FINAL
Environmental Impact Report
Merced Gateway Master Plan
City of Merced, Merced County, California
State Clearinghouse Number 2015101048

Date: June 7, 2017

SECTION 2: RESPONSES TO WRITTEN COMMENTS

Exhibit 1

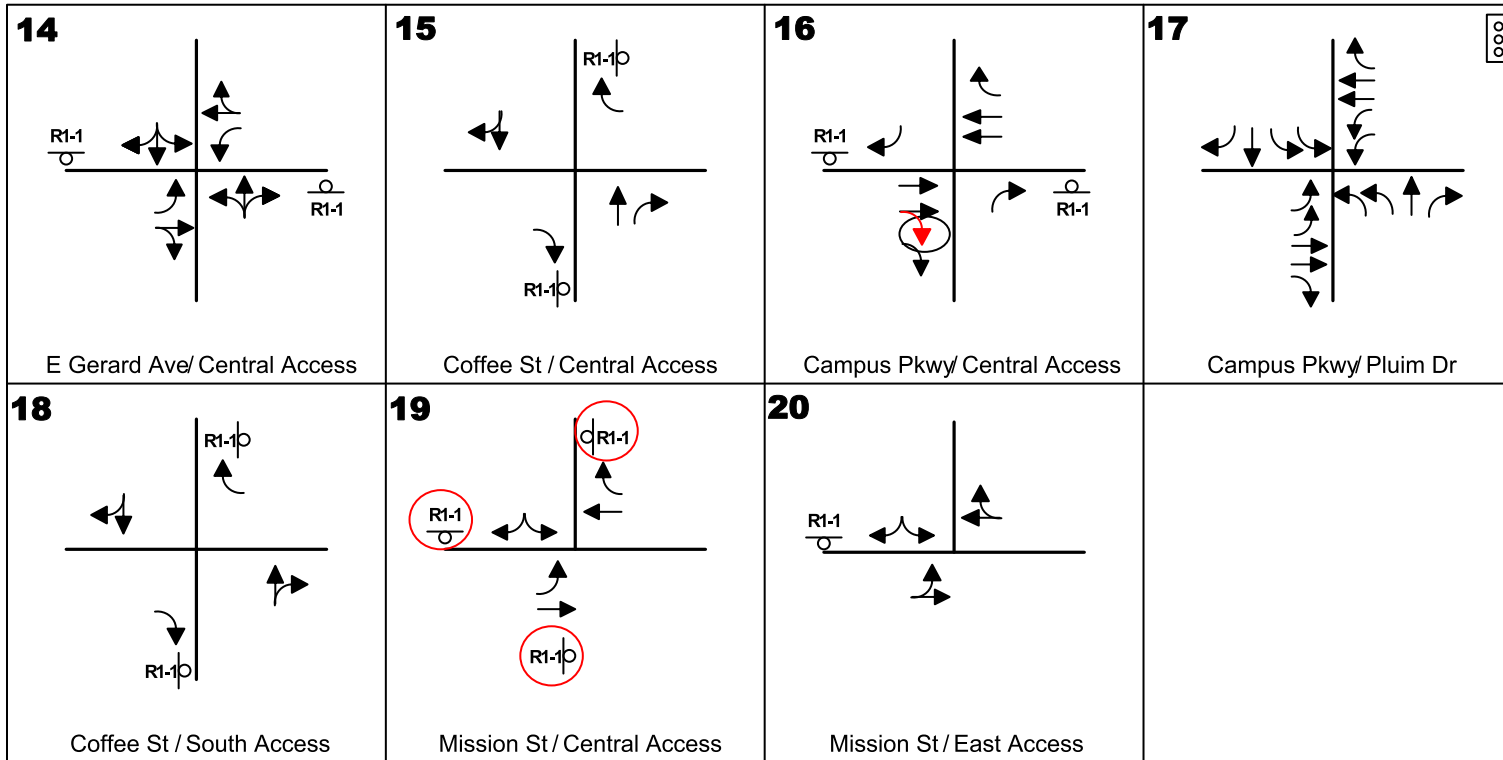
The project applicant requests that the project description be amended to Match Alternative 2 of the Circulation Element Alternative. After further discussion between the project applicant and the adjacent property owner, it was determined that the Pluim Drive extension would provide greater access for both property owners and advance and enhance all of the project objectives. We intend to commence construction of the Pluim Drive Extension no later than the issuance of the first building permit for phase 5 of the project. One half of the roadway will be located on the Merced Gateway, LLC property (adjacent land owner) and the other half on Gateway Park Development Partners, LLC property. Attached hereto is a revised site plan that includes the construction of the Pluim Drive extension. Please advise at your earliest convenience if additional information is needed to amend the project description.

Exhibit 3.11-11 Mitigations Existing Plus Project / Access as Proposed Lane Configurations

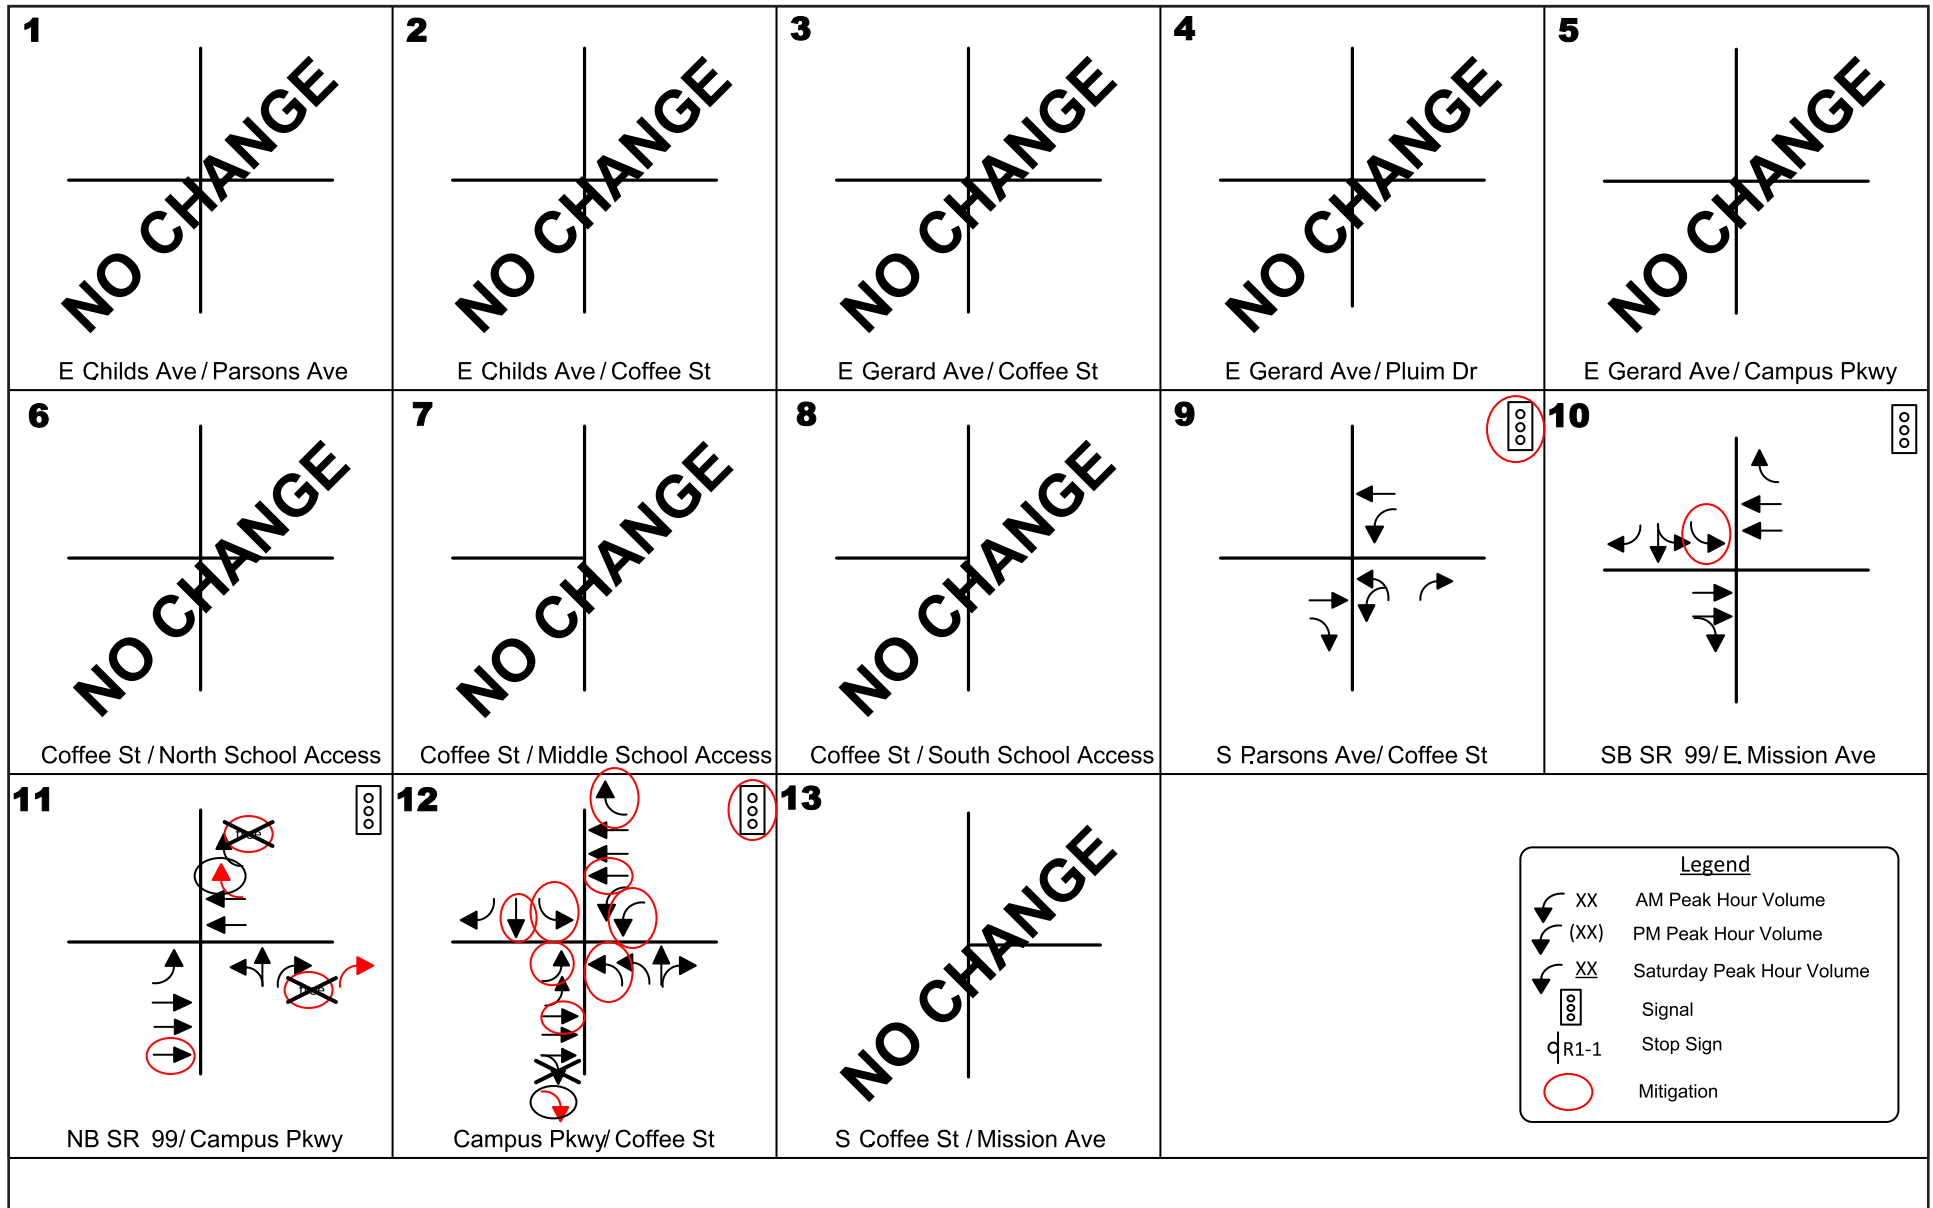
| <ul style="list-style-type: none"> a. The mitigation proposes making the right-turn lane of the northbound SR-99 off-ramp “free” at the intersection of SR-99 NB ramps/Mission Ave under mitigations for “Existing Plus Project with Access as Proposed & General Plan Streets”, “Existing Plus Approved Project Plus Project (EPAP Plus Project)/Access as Proposed”, and “Cumulative Plus Project with Access as Proposed & General Plan Streets”. This proposed mitigation will create potential safety issues and turning movement conflicts between the northbound right-turn & eastbound Mission Avenue. This right-turn movement needs signalized controls. b. The mitigation proposes making the right-turn lane from the westbound Mission Avenue to the northbound SR-99 on-ramp “free” at the intersection of SR-99 northbound ramps/Mission Ave under mitigations for “Existing Plus Project with Access as Proposed & General Plan Streets”, “Existing Plus Approved Project Plus Project (EPAP Plus Project)/Access as Proposed”, and “Cumulative Plus Project with Access as Proposed & General Plan Streets”. This proposed mitigation will create potential safety issues and turning movement conflicts between Mission Avenue’s westbound right-turn lane & its eastbound left-turn lane. This right-turn movement needs signalized | 6 |

The City of Merced and Caltrans have consulted on the issues associated with the State Route 99 (SR-99)/Mission Avenue intersection and have identified an applicable strategy to address these concerns noted in this comment. The northbound SR-99 ramps approach to Mission Avenue will not include a "free" right-turn lane, but instead a second northbound right-turn lane will be provided. These improvements would be required for both the proposed project and the GP Circulation Alternative. In addition, a second right-turn lane will be provided at the project's mid-block driveway on Campus Parkway under the proposed project and the eastbound shared through/right

turn at Coffee and Campus Parkway will be split into a separate through lane and separate right-turn lane. These changes are noted in the revised Figures 22, 23, 24, 26, 27, 28, and 29 and revised Tables 37, 41, and 43 from the Traffic Study in Appendix I to the DEIR and the corresponding Exhibits 3.11-11, 3.11-12, 3.11-13, 3.11-18, 3.11-19, 3.11-24, 3.11-25, and 3.11-26 and Tables 3.11-16, 3.11-28, 3.11-37, 3.11-38, and 3.11-39, which are included in the Errata to the Draft EIR as part of this Final EIR.

Exhibits 3.11-11, 3.11-12, 3.11-13, 3.11-18, 3.11-19, 3.11-24, 3.11-25, 3.11-26, and 3.11-27, and Tables 3.11-16, 3.11-28, 3.11-37, 3.11-38, and 3.11-39 from the DEIR (corresponding to Figures 22, 23, 24, 26, 27, 28, and 29 and revised Tables 37, 41, and 43 from the Traffic Study in Appendix I of the DEIR) are also changed to reflect the revised mitigation measures and the correction to the Mitigated Cumulative Year 2035 condition for Mission Avenue/State Route 99 northbound and southbound ramps, from LOS “D” to “B” in the AM Peak Hour, and the Mission Avenue/State Route 99 southbound ramps from LOS “C” to “B” in the PM peak hour. The revised pages of the EIR follow.

Exhibit 3.11-13 Mitigations Existing Plus Project with General Plan Streets Lane Configurations

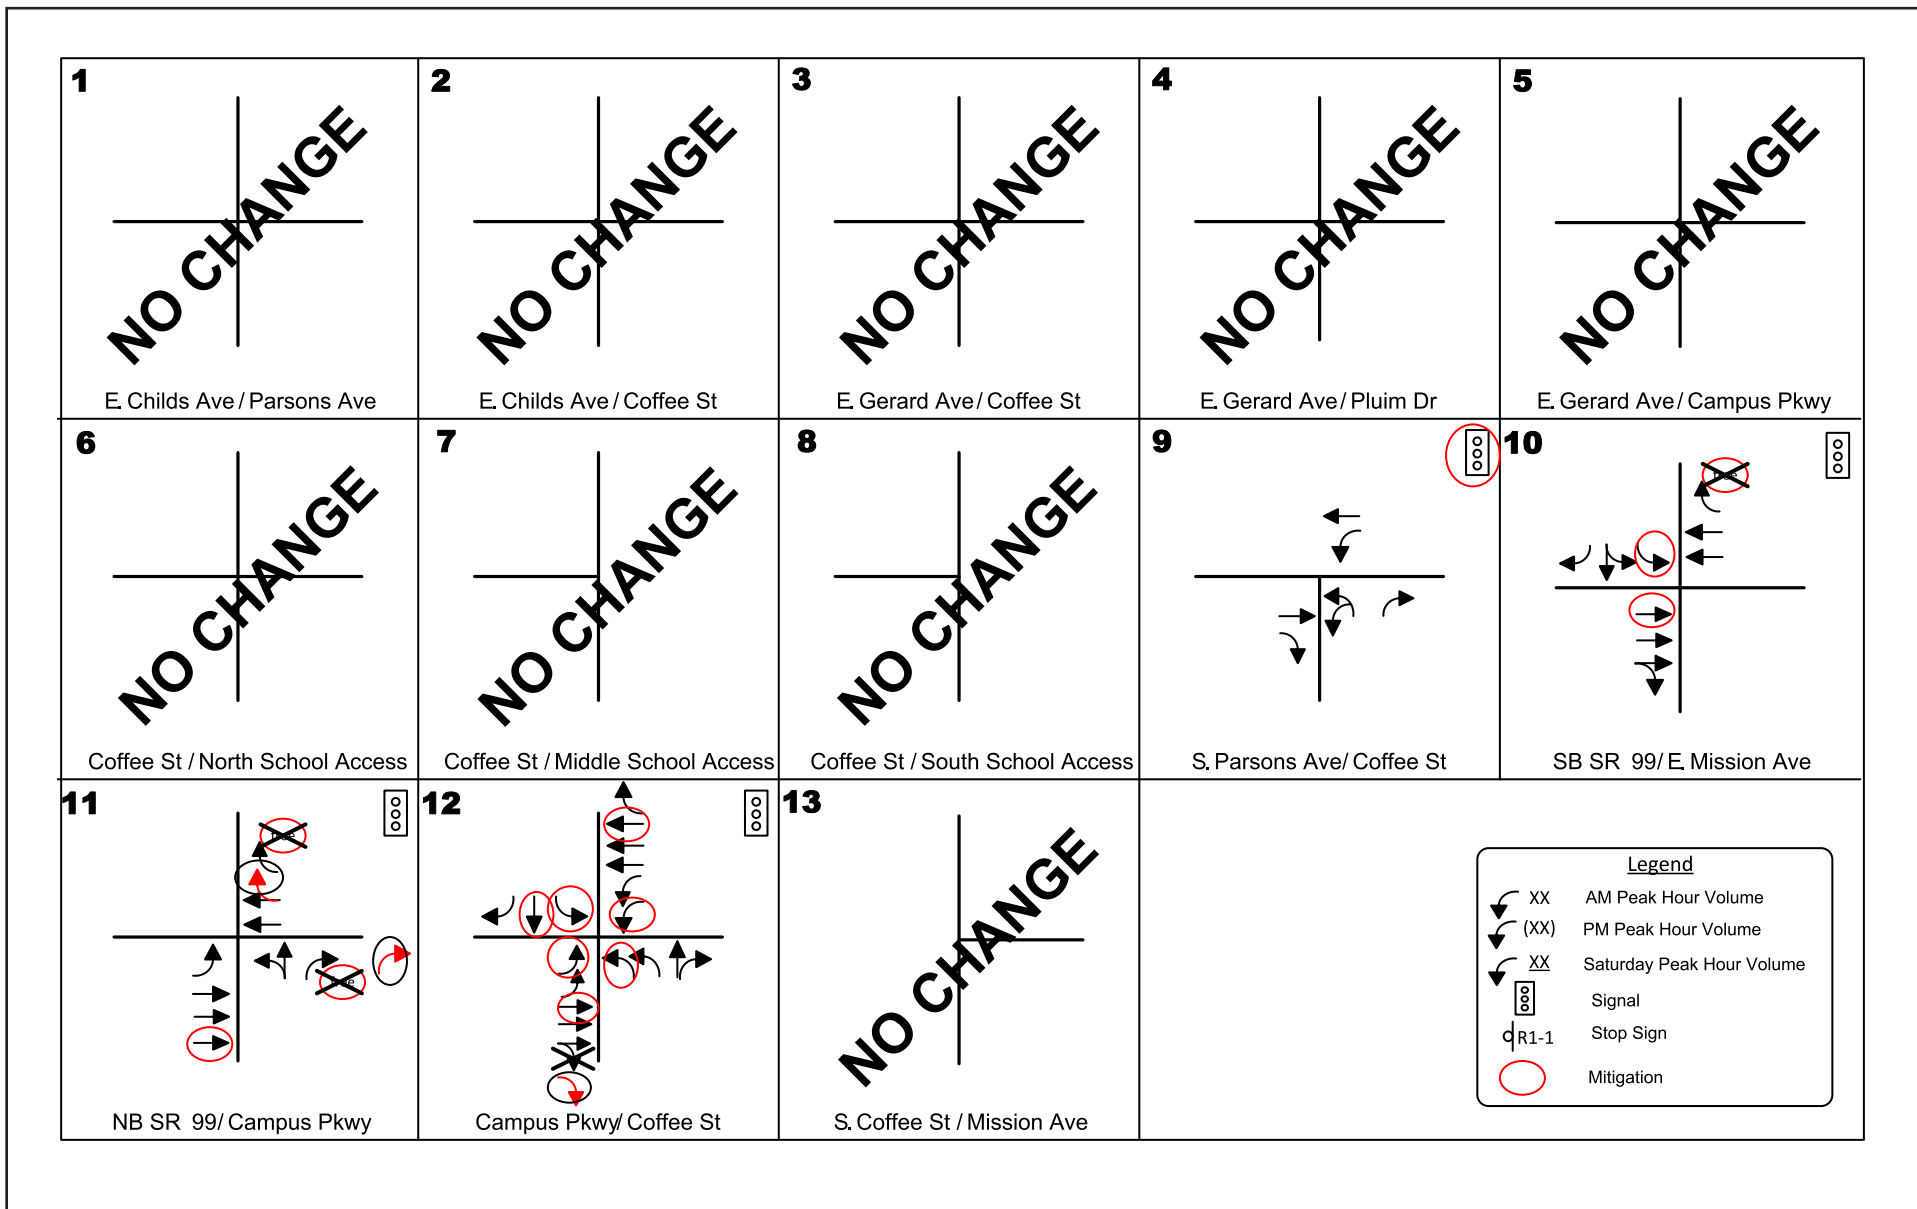
d. According to Figure 22 (Mitigations for Existing Plus Project/Access as Proposed) and Figure 24 (Mitigations for Existing Plus Project with General Plan Streets) of the TIS, there will be two WB left-turn lane at Campus	13

The commenter points out that according to Figure 22 (Mitigations for Existing Plus Project/Access as Proposed) and Figure 24 (Mitigations for Existing Plus Project with General Plan Streets) in the Traffic Study would require a second westbound left-turn lane at Campus Parkway/Coffee Street, but review of that second left-turn lane is not provided in the Mitigation Synchro file.

Exhibit 3.11-19 Mitigations Existing Plus Approved Projects (EPAP) Plus Project / Access as Proposed Lane Configurations

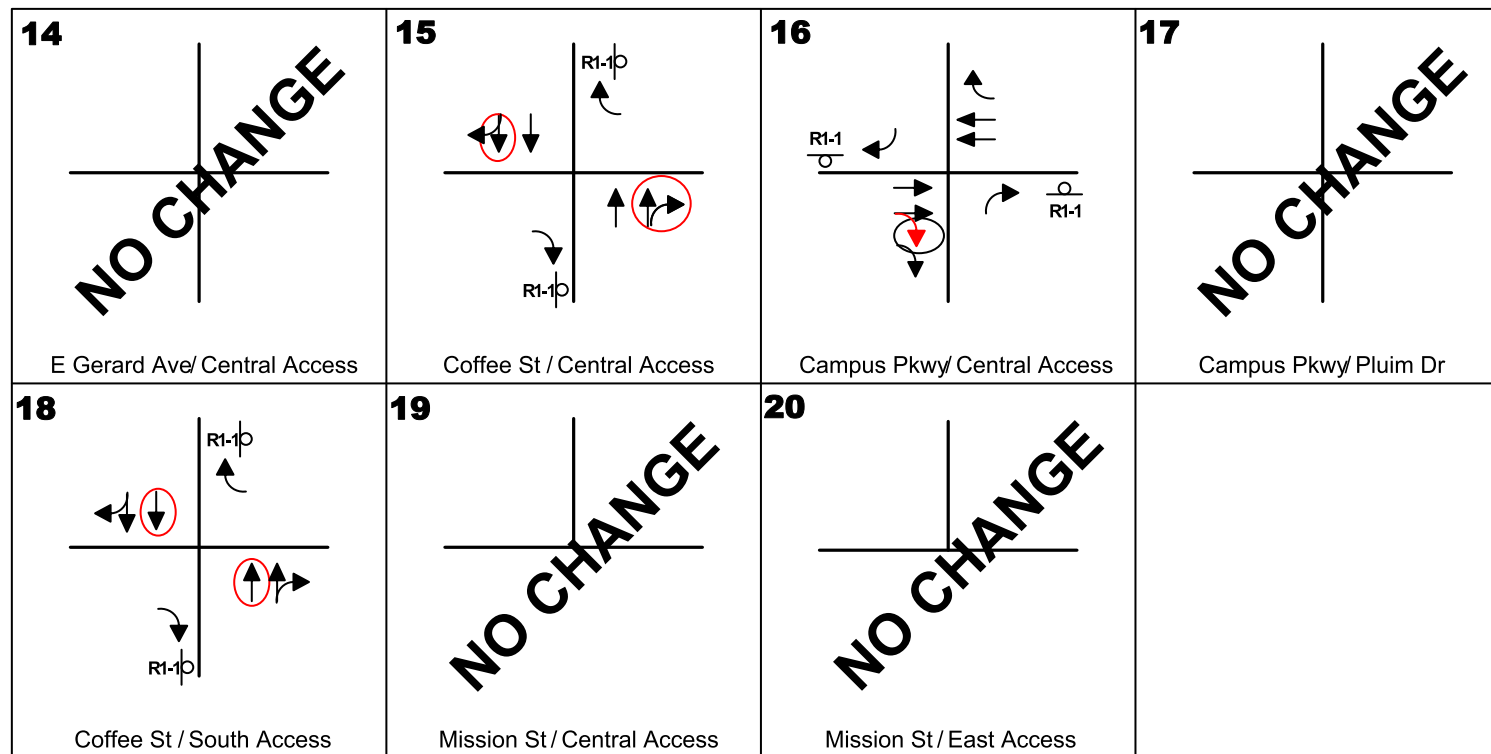
7. The DEIR's TIS needs to be revised to provide feasible mitigations under "EPAP Plus Project and Cumulative Plus Project Access as Proposed". The TIS analyzes the traffic impact under this condition, and indicates that the adjacent approved projects will worsen the traffic conditions at the ramp intersections and adjacent intersections, in addition to impacts from the Merced Gateway project. The TIS proposes the using the same "Existing Plus Project" mitigations as the mitigation for the "EPAP Plus Project & Cumulative Plus Project Access as Proposed". However, these proposed mitigations do not mitigate the project's significant impacts to traffic. For example, with these mitigations at the SR-99 NB Ramps/Mission Ave, the LOS is still E and F in the PM peak and Saturday as shown in Table 42, Mitigated EPAP Plus Project Conditions, Merced Gateway TIS.

The City of Merced and Caltrans have consulted on the issues associated with the SR-99/Mission Avenue intersection and have agreed that the mitigation measures as revised above are sufficient to address these concerns. The resulting Levels of Service (LOS) would be similar to those identified in the DEIR but would still result in significant and unavoidable impacts as indicated in the DEIR.

Exhibit 3.11-26 Mitigations Cumulative Plus Project with General Plan Streets Lane Configurations

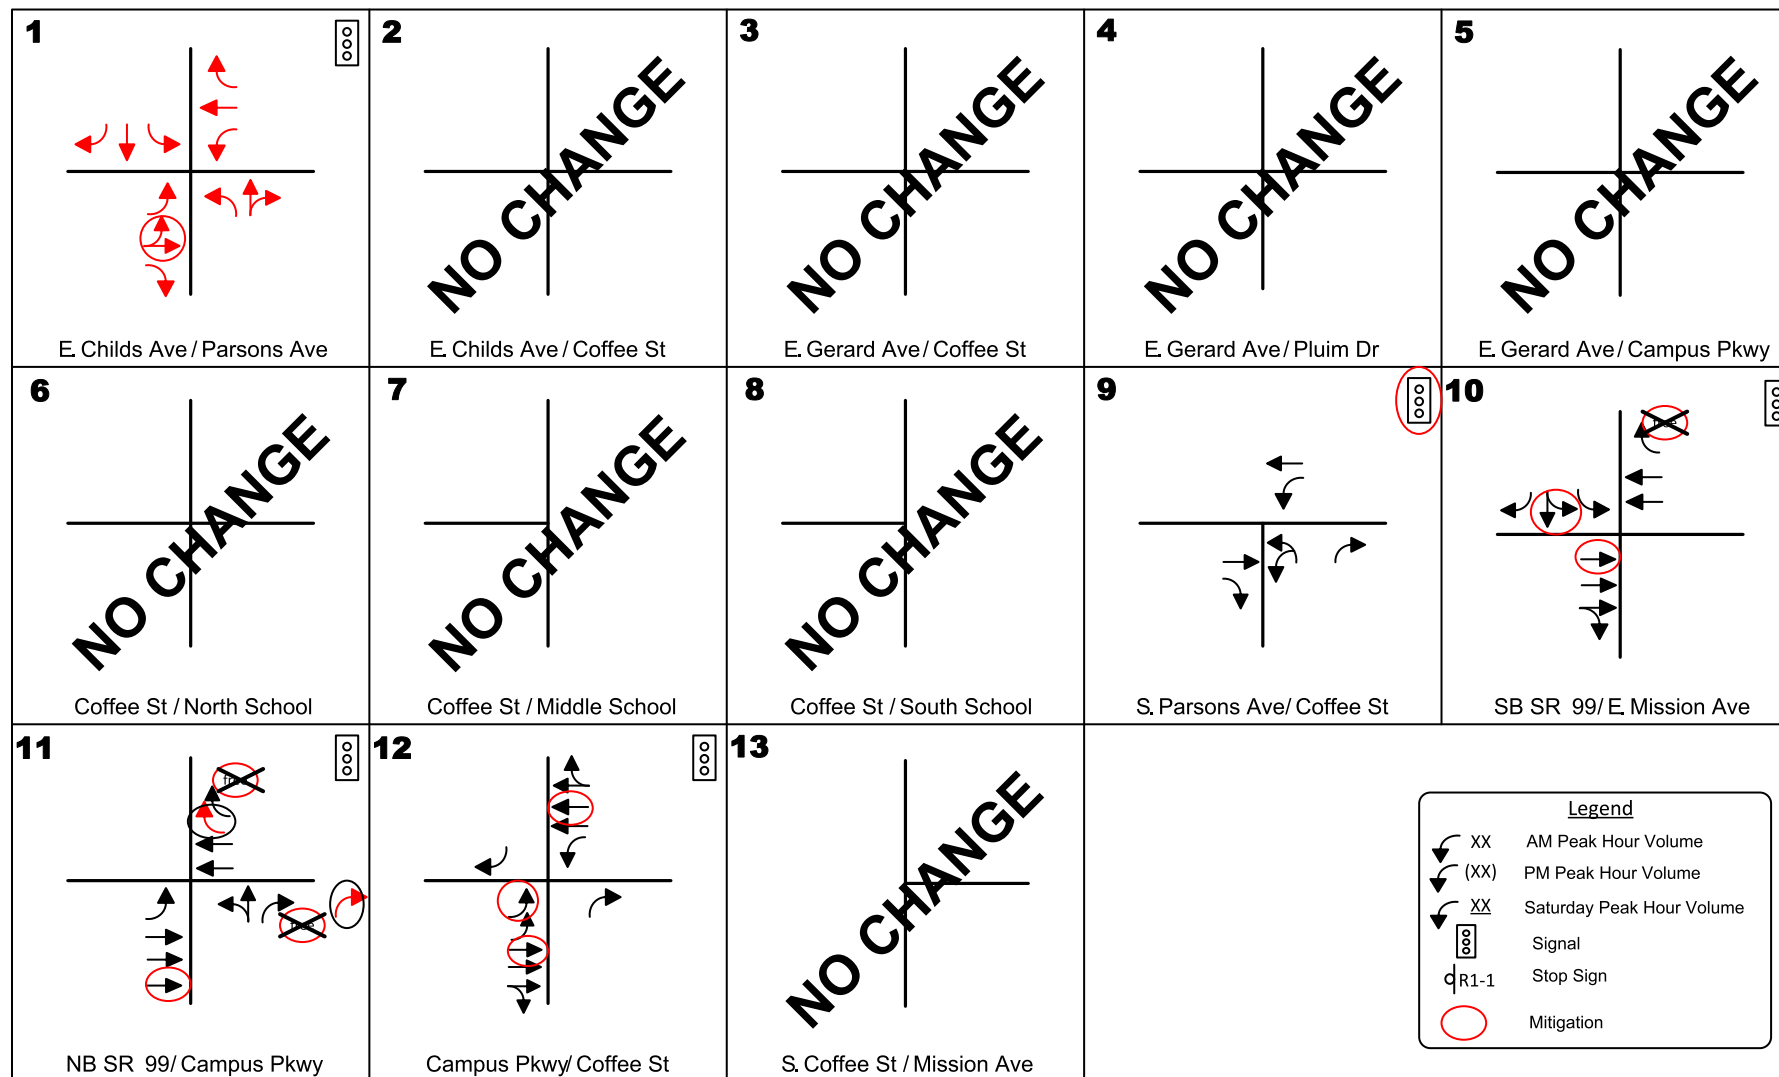
8. Under the "Access as Proposed" scenario, the Merced Gateway DEIR's TIS provides the traffic analysis and mitigations for "Existing Plus Project Conditions", "EPAP Plus Project Conditions", and "Cumulative Plus Project Conditions". However, under the General Plan Circulation scenario, the TIS ignores the "EPAP Plus Project Conditions". The DEIR's TIS needs to mitigate the project's significant impacts during the "EPAP Plus Project with General Plan Circulation Conditions".
